TRANSMITTAL LETTER FOR THE DRAFT RESPONSES TO U S EPA REGION V
COMMENTS ON THE INTERIM MEASURES WORK PLAN FOR SOLID WASTE
MANAGEMENT UNIT 13 MINE FILL B NSA CRANE IN
6/13/2008
TETRA TECH

RE: **Draft**
Response to United States Environmental Protection Agency (EPA) E-Mail Comments
Dated June 12, 2008 on Interim Measures Work Plan (IMWP) for Solid Waste
Management Unit (SWMU) 13 (Mine Fill B)
Naval Surface Warfare Center (NSWC) Crane
Crane, Indiana

**RESPONSE TO COMMENTS (RTCs) DATED JUNE 12, 2008
FROM UNITED STATES ENVIRONMENTAL PROTECTION AGENCY (EPA)
(E-MAIL FROM PETER RAMANAUSKAS)
ON THE INTERIM MEASURES WORK PLAN (IMWP) EPA RTCs DATED JUNE 9, 2008
FOR SWMU 13 – MINE FILL B
NAVAL SURFACE WARFARE CENTER
CRANE, INDIANA**

CONTRACT NO.	0352
OWNER NO.	0020
APPROVED BY	DATE
DRAWING NO.	REV.
FIGURE 5-1	0

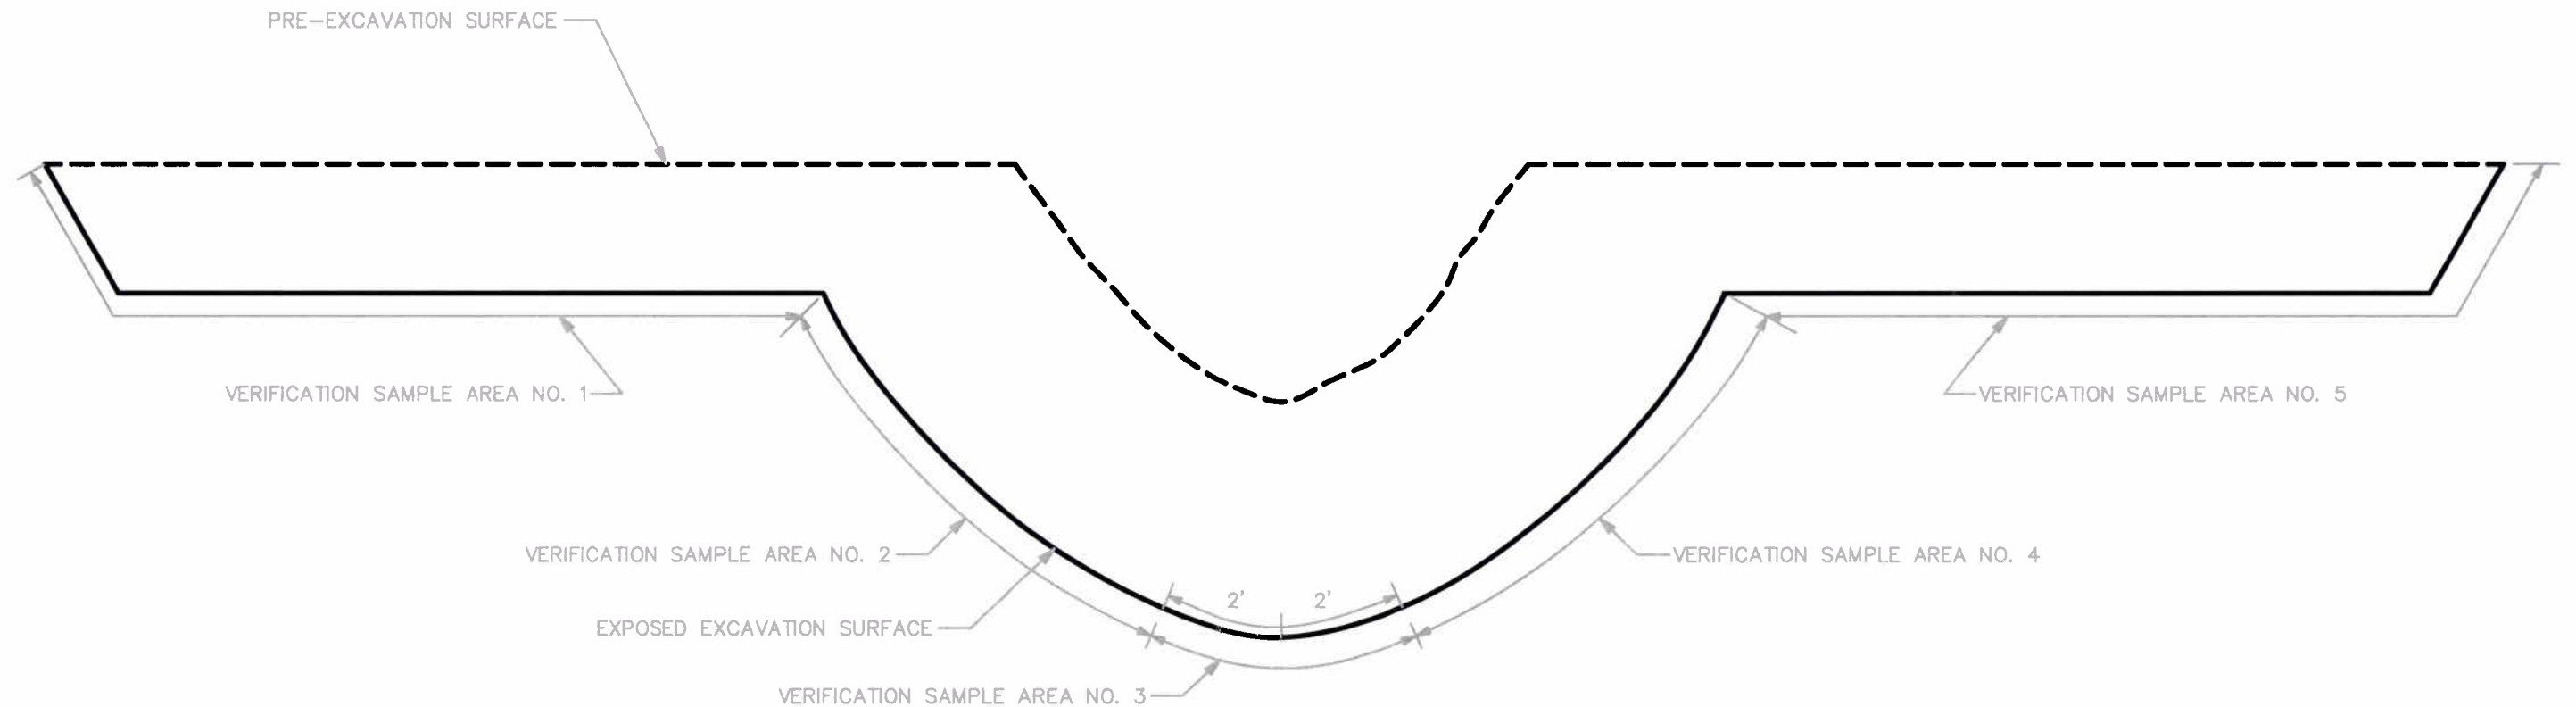
Regarding EPA-6: For the channel excavation areas, we propose you also take a composite sample every 100 ft along the low-point of the trench (i.e. along the bottom of the V/U). Since the language associated with the sampling will be incorporated in this IMWP and the approved QAPP for the project containing different sampling language will not be modified, describe how will you ensure that the contractor will be following the correct sampling scheme. Please reiterate in the IMWP how many aliquots will make up a composite sample.

Response to EPA-2(6-12-08): To accommodate the collection of an additional composite sample along the centerline of the drainage channel following excavation, the text has been revised to

include the collection of five composite samples for every 100 linear feet of drainage channel excavated. Due to the irregular shape of the excavation, the fifth composite sample will be collected from an area designated as the base of the excavation along the centerline of the channel. This area will measure approximately 4 feet wide centered on the center of the drainage channel. The text in Section 5.2, Subsection, "Drainage Channel Excavation Areas" has been revised as follows:

- *"Drainage Channel Excavation Areas - Verification samples will be collected from the exposed drainage channel base and sidewalls and the exposed overflow area floors. As shown on Figure 5-1, due to the irregular shape of the drainage channel excavation, two verification samples will be collected from the exposed overflow floor areas (Areas 1 and 5) located on each side of the channel (i.e., from the channel overflow areas), two verification samples will be collected from the two exposed drainage channel sidewall surfaces (Areas 2 and 4), and one verification sample will be collected along the exposed drainage channel base where the exposed base is not bedrock (Area 3). Verification samples will be composite samples as described in the QAPP (TtNUS, 2006). These five composite samples make up one set of verification samples. At a minimum, one set of verification samples will be collected from each drainage channel segment and for every 100 linear feet of drainage channel excavation. Therefore, based on the proposed length of drainage channel excavation (470 feet split across four channel segments), seven sets of samples, consisting of five verification samples per set, will be collected from the proposed SWMU 13 drainage channel excavation areas. In the event that a drainage pipe is encountered during the drainage channel excavation process, the frequency of verification sample collection will be increased to one set of verification samples for every 25 linear feet of drainage channel excavation for a distance of 100 feet downstream of the exposed drainage pipe. The verification samples will be analyzed for PCBs. The results of these verification samples will be evaluated to determine whether PCB contamination remains in the exposed surface soil at concentrations greater than 1 mg/kg. In the event that a verification sample result exceeds 1 mg/kg (from floor samples or sidewall samples), the Navy may direct that the excavation be extended in the appropriate direction(s) to remove this soil. The extent of additional excavation will depend on the location and concentration of the exceedances. Additional verification samples will be collected following any additional excavation. Excavation expansion may continue until verification samples indicate that PCB concentrations are less than 1 mg/kg. The length of drainage channel excavation is based on the results of the RFI and 2006 sediment-sampling events. The results of the verification sample will not increase the length of drainage channel excavation areas."*

The revised Figure 5-1 is presented in Attachment 1.
